# MATANUSKA-SUSITNA BOROUGH PLATTING BOARD AGENDA

## MATANUSKA-SUSITNA BOROUGH PLATTING BOARD AGENDA JUNE 18, 2020

PRELIMINARY PLAT: **FOLSOM ACRES MASTER PLAN**  
 LEGAL DESCRIPTION: **SEC 31, T18N, R2E, SEWARD MERIDIAN, AK**  
 PETITIONER: **FOLSOM REVOCABLE TRUST**  
 SURVEYOR/ENGINEER: **HANSON LAND SOLUTIONS**  
 ACRES: 32.39 PARCELS: 19  
 REVIEWED BY: CHERYL SCOTT CASE: 2020-068

REFERENCE NUMBER:  
C-1.0  
SHEET 6 OF 14

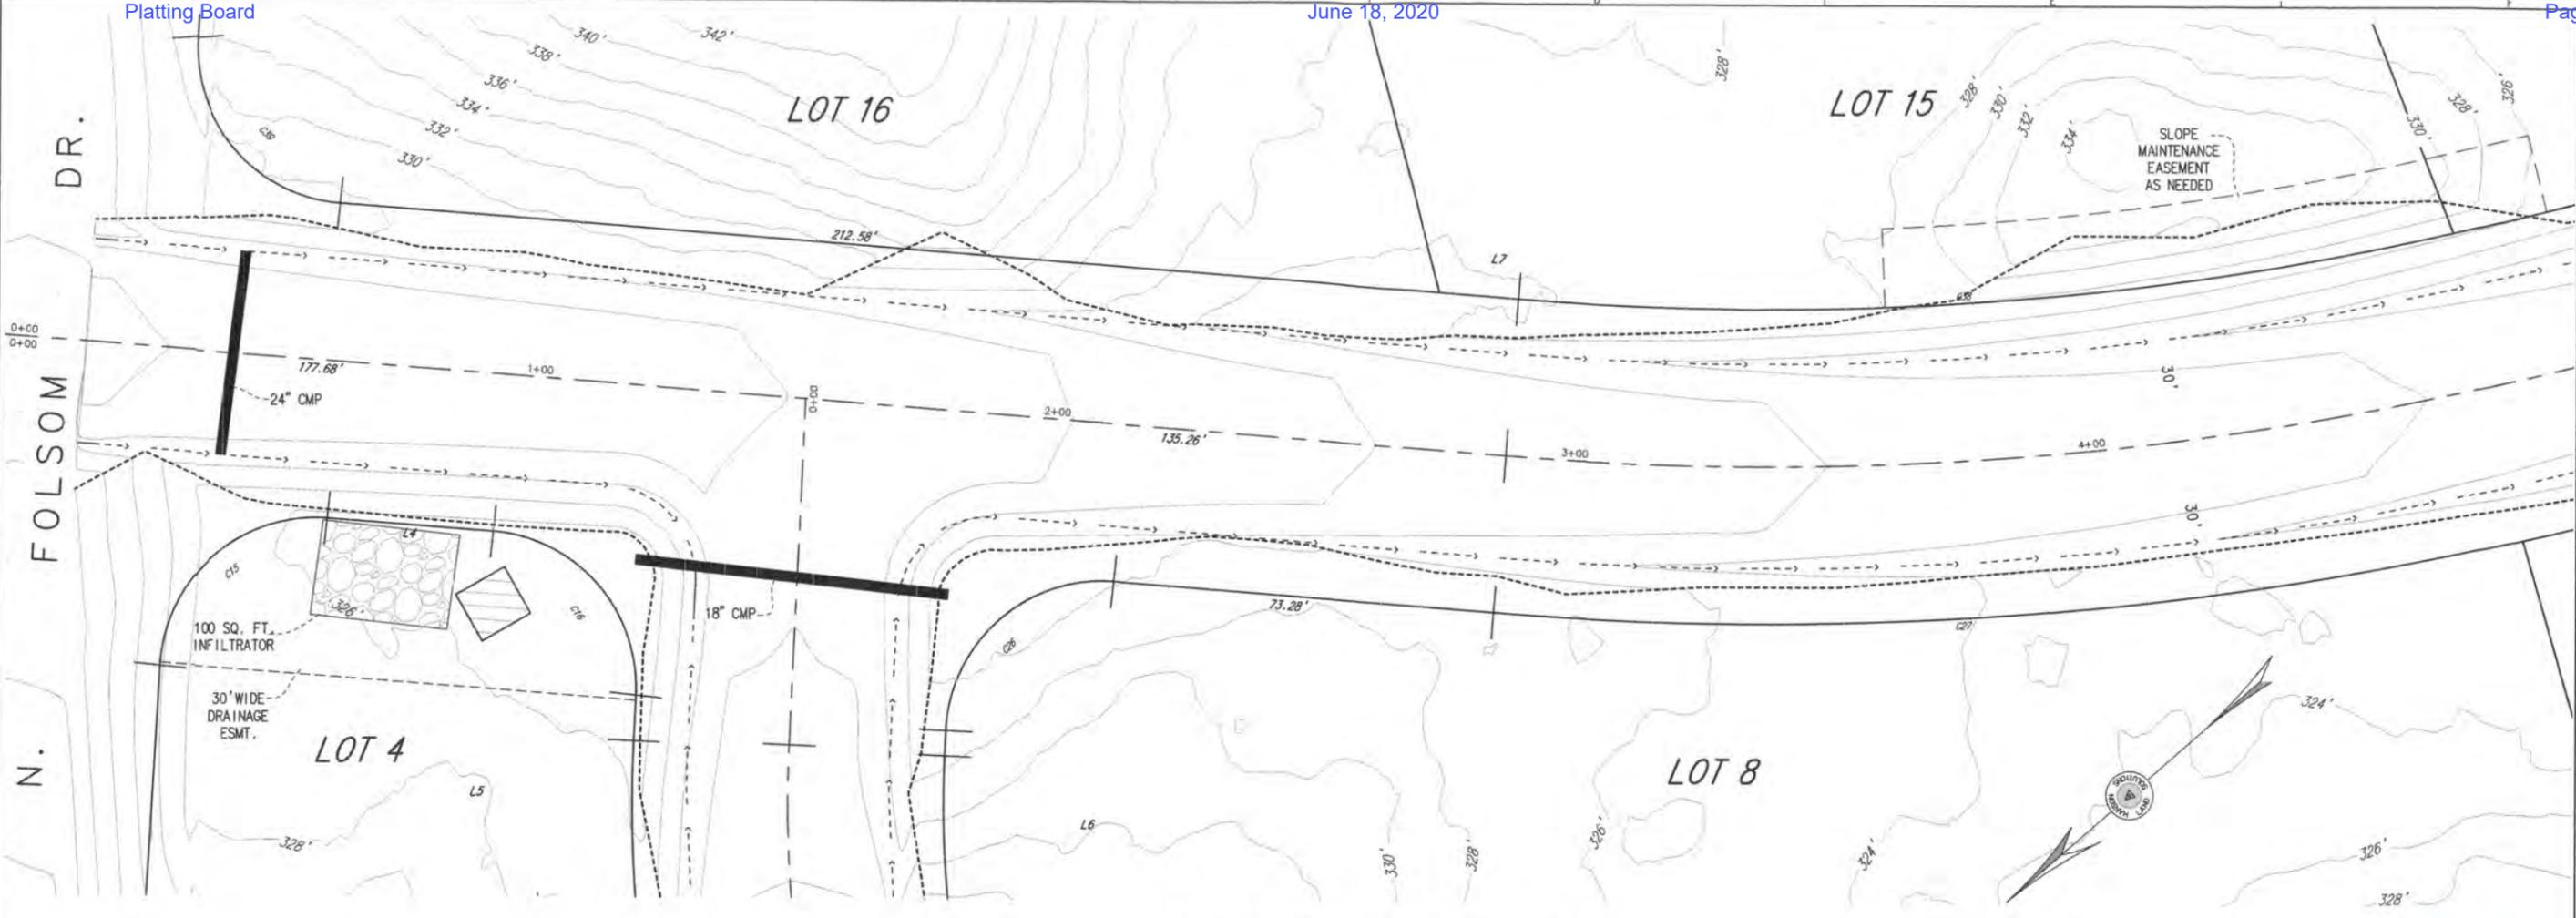
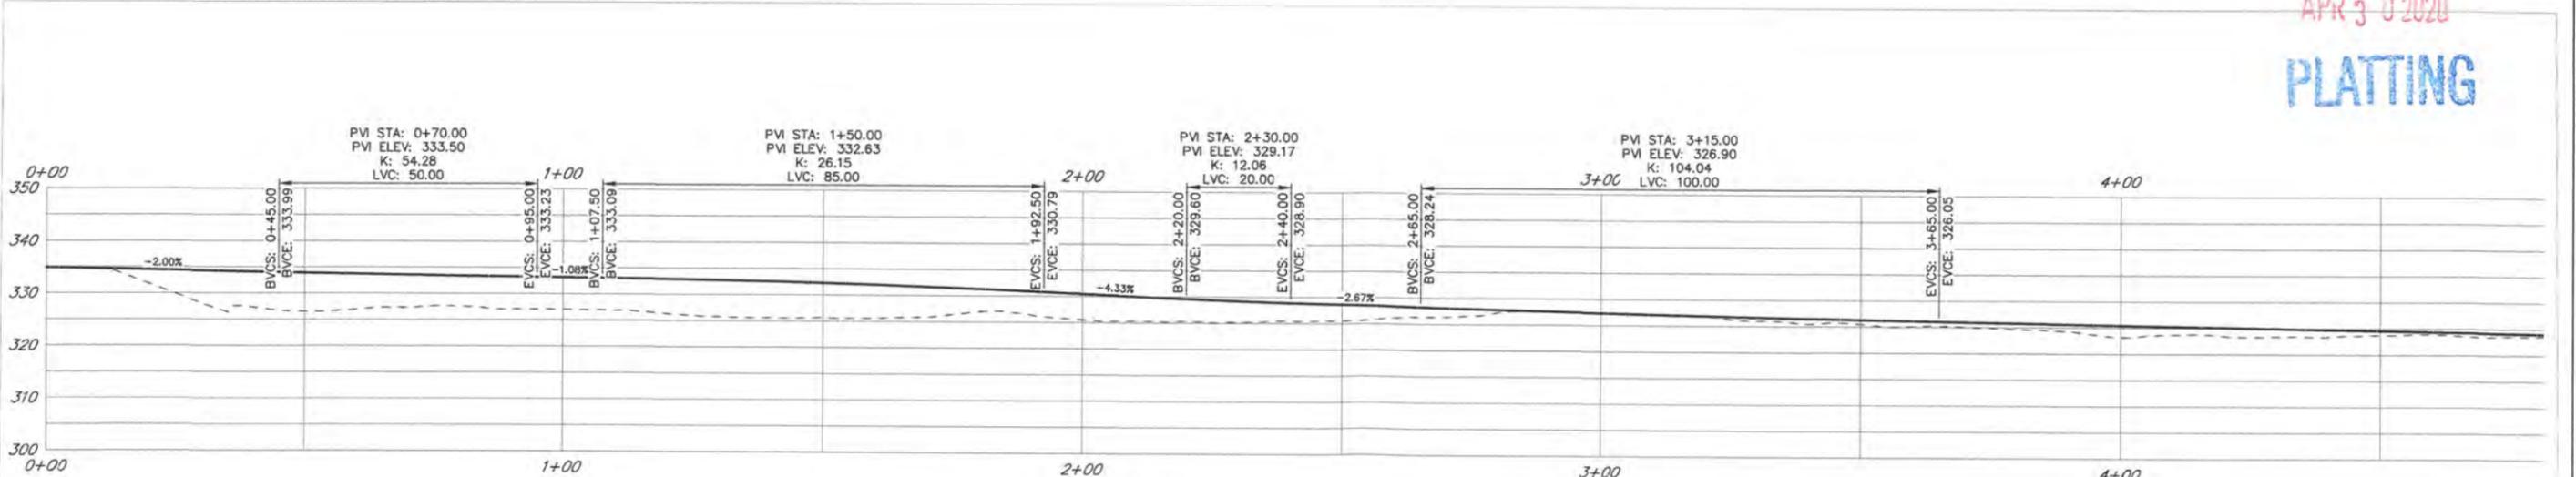
Hanson Land Solutions provided road plan and profiles for the interior streets and where these streets intersect with Folsom Drive. **(Exhibit H)** Centerline profiles are required when grades exceed 6% per the SCM E01.1 and centerline grades of residential streets are not to exceed 10 percent per SCM A04.4(b). The only proposed street with grades over 6% but less than 10% is Spur Circle.
